## Summary of Items Discussed in 4/2015 APSEC Discussion Forum on 28 August 2015

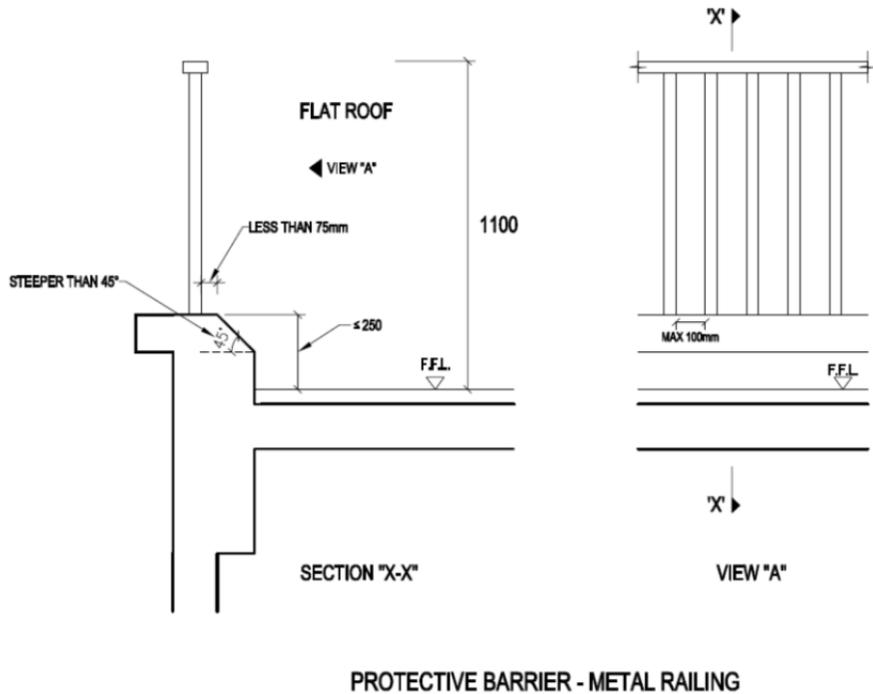
10.	<p><u>Fireman Lift and Fireman Lift Lobby</u></p> <p>The diagram shows fireman lift arrangement where 2 lift doors are provided at the floor. The Front lift door faces a common passenger lift lobby, open office area or private flat area. The Rear lift door faces the fireman lift lobby.</p> <p>The above arrangement had been acceptable to BD and FSD before, provided that only the Rear Lift Door will operate and the Front Door will remain shut upon the activation of the Fireman Switch (to be stated in the FS Notes).</p> <p>Please advise whether there had been any recent changes in consideration to the</p>	<p>The BD confirmed that the arrangement as shown would be acceptable provided that the front lift door should have an FRR of -/120/120.</p> <p>[Post Meeting Note: FSD subsequently had meetings with APs and indicated to the BD that the arrangement as shown in the diagram would no longer be acceptable to FSD unless the lobbies which the firemen's lifts open to are firemen's lift lobbies complying with Clause D11.1 and D11.4 of the FS Code 2011. New plans bearing the design as indicated, without covered by previous approvals and submitted since 2016 will not be accepted.]</p>

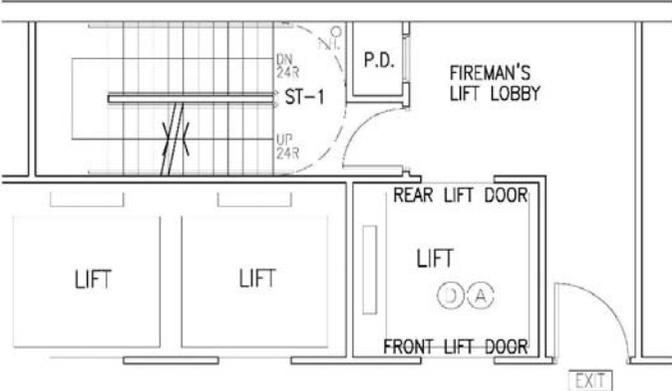
3.	<p><u>Building (Planning) Regulation 39 - Staircases</u></p> <p>According to Clause B3.1 of the FS Code, a single-family house having not more than 3 main storeys and with level of the highest floor of not more than 13m above ground level does not need to comply with Part B – Means of Escape of the Code, including, inter alia, provisions relating to required staircases design. By virtue of the above, it is logical to infer that B(P)R 39 should likewise not be applicable to such single-family house; or at least, favourable consideration should be given to application for exempting this Regulation from applying to single-family house. Please confirm that our understanding is correct.</p>	<p>The BD advised that notwithstanding that the requirements on means of escape under the FS Code did not apply to this type of single family house under Clause B3.1, regulation 39 of the Building (Planning) Regulations (B(P)R) should be complied with as the internal staircase of the house being the only staircase should be regarded as a main staircase. Accordingly, as stipulated in B(P)R 39(3), the staircase should have not more than 16 steps in any flight without the introduction of a landing.</p> <p>The BD clarified that winders might be acceptable if the minimum dimensions on treads measured at the centre of the flight and risers stipulated in regulation 39(3)(c) of the B(P)R were complied with. In addition, the landing did not need to be of square shape, and might not be strictly required to meet the minimum dimension of the staircase width under a case by case consideration.</p> <p>[Post-meeting Note : The BD clarified that under regulation 42 of the</p>

Items proposed by Convenors for Discussion	Summary of Discussion and BD's Responses
		<p>B(P)R, the minimum dimension of the landing should not be less than the width of the staircase to which it leads.]</p> <p>To cater for extreme planning and site constraints envisaged, the BD would take a pragmatic approach for those projects which GBP had been approved yet the requirements of B(P)R 39 could not be fully complied with.</p>

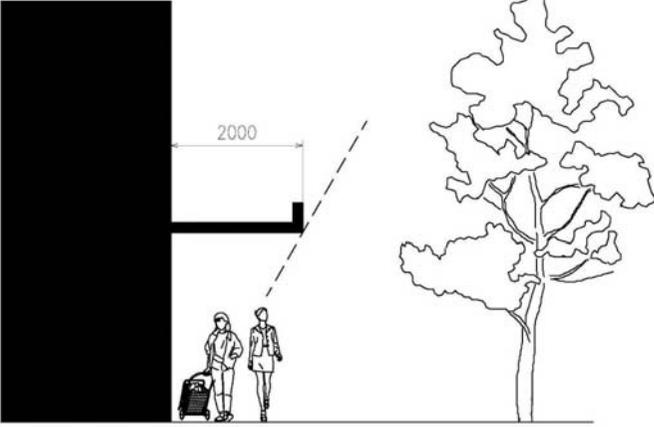
4.	<p><u>Covered Landscape Area underneath Domestic Towers</u></p> <p>We are given to understand that based on an earlier BCI decision, whenever the covered landscaped area at G/F underneath domestic tower is to be exempted from GFA, the flat roofs at transfer plate immediately above have to be designated as common area (i.e. cannot be of saleable flat roofs), despite the transfer plates are of reasonable extent in such circumstances. However, referring to the attached sketch section for a hypothetical case, if we are to extend the domestic units at 1<sup>st</sup> typical floor to cover up the same transfer plates, the resulting flat roofs at 2<sup>nd</sup> typical floor can then be readily accepted as saleable flat roofs. Thus, it appears that the requirement in the former scenario is far too onerous and restrictive.</p> <p>Indeed, the Lands Department has separately issued a practice note earlier in 2014 setting out their criteria for accepting private flat roof/garden on top of GFA exempted area, and BD may not be necessary to further impose additional restrictions on this subject.</p>	<p>The BD reiterated its previous response in Item 11 of the Summary of Items Discussed in APSEC Discussion Forum held on 3.8.2012 that it would depend on whether it was a genuine and reasonable design. In addition, common external soil and waste stacks running across or passing through the transfer plate including working space and access should be designated as common parts in accordance with paragraphs 2 and 3 of PNAP APP-93.</p> <p>The BD advised that when considering an application for exemption of covered landscaped areas underneath a transfer plate from GFA calculations, the reasonableness and extent of the transfer plate should be the relevant considerations whereas the inclusion of the minor flat roof areas outside the footprint of the tower in the saleable areas might not be relevant.</p>
